Applies To: **2007–09 MDX – ALL**

MID or Navi Shows a Check Engine Oil Level Message, Low Oil Pressure Indicator May Be On

(Supersedes 09-012, dated June 17, 2009, to revise the information marked by the black bars)

Look for an "R72" mark on the right side of the oil pump.

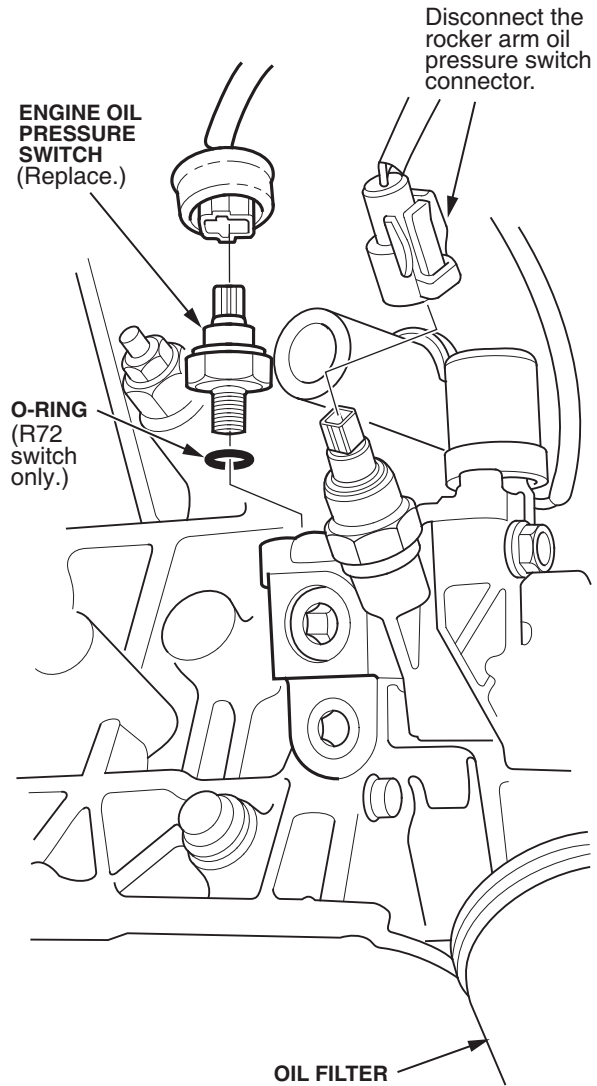
1. Start the engine, turn the steering wheel fully to the right, then shut off the engine.
2. Raise the vehicle on a lift, and make sure it's securely supported.
3. Detach the front clip from the right front inner fender. Pull back the edge of the inner fender, and look for an "R72" mark on the right side of the oil pump:
 - If the oil pump has the "R72" mark, use P/N 37240-R72-A01 for the new engine oil pressure switch.
 - If the oil pump does not have the "R72" mark, use P/N 37240-RDM-A01 for the new engine oil pressure switch.
